STATE OF CONNECTICUT
CONNECTICUT SITING COUNCIL

Petition No. 1410

GREENSKIES CLEAN ENERGY, LLC'S RESPONSES TO THE SEPTEMBER 17, 2020 SET OF INTERROGATORIES DIRECTED TO GREENSKIES CLEAN ENERGY, LLC FROM PROPONENTS FOR RESPONSIBLE EMPLACEMENT OF STONINGTON SOLAR ("PRESS")

Elmridge Golf Diversion Berm - East Site

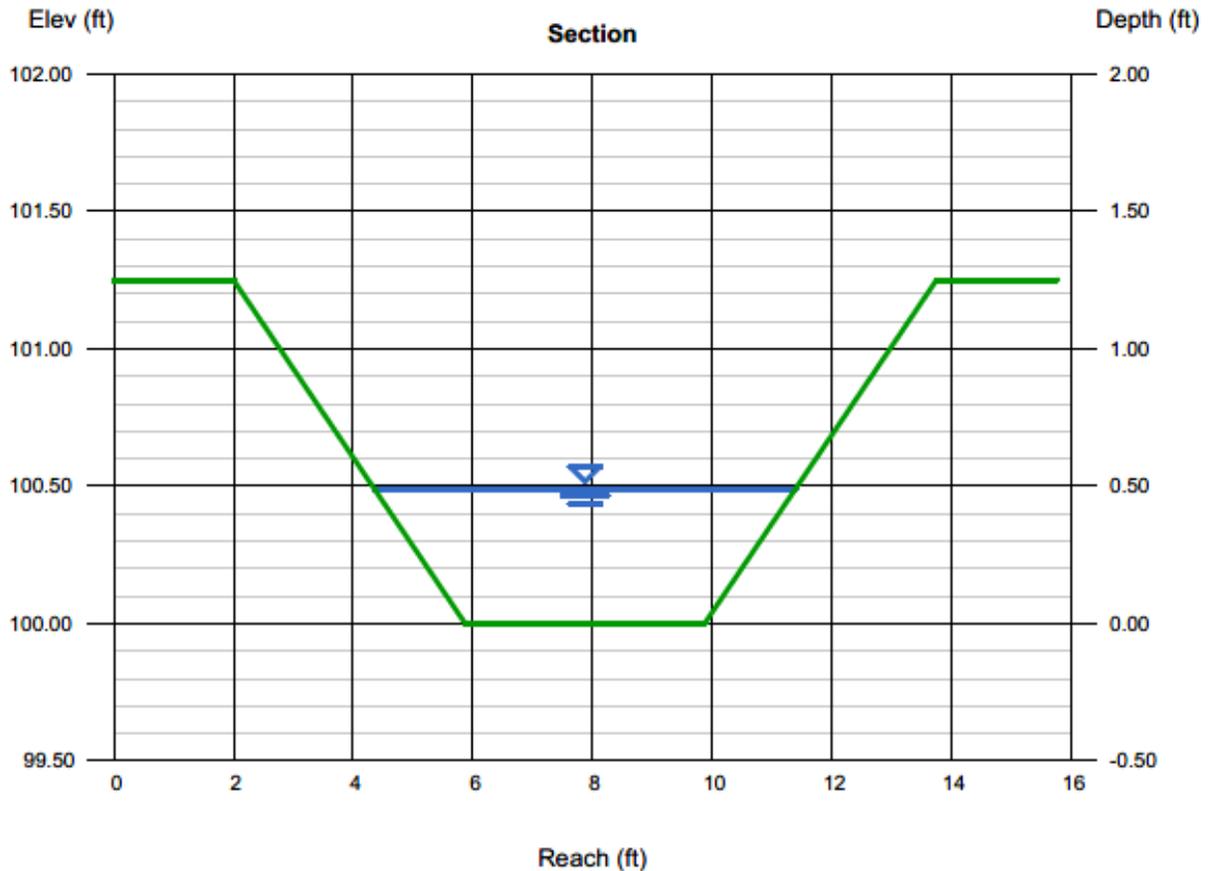
- 12. With respect to the earth diversion berm shown on Sheet LA-2, please provide the hydrologic calculations that demonstrate the berm can divert the runoff from the area of the panels immediately south of Basin #2 to the basin without overtopping.**

Peak flow at the diversion berm for the ten (10)-year storm event is approximately ten (10) cfs with a flow depth of 0.5 feet. The overall height of the berm is 1.25 feet. Please also refer to Exhibit B attached hereto.
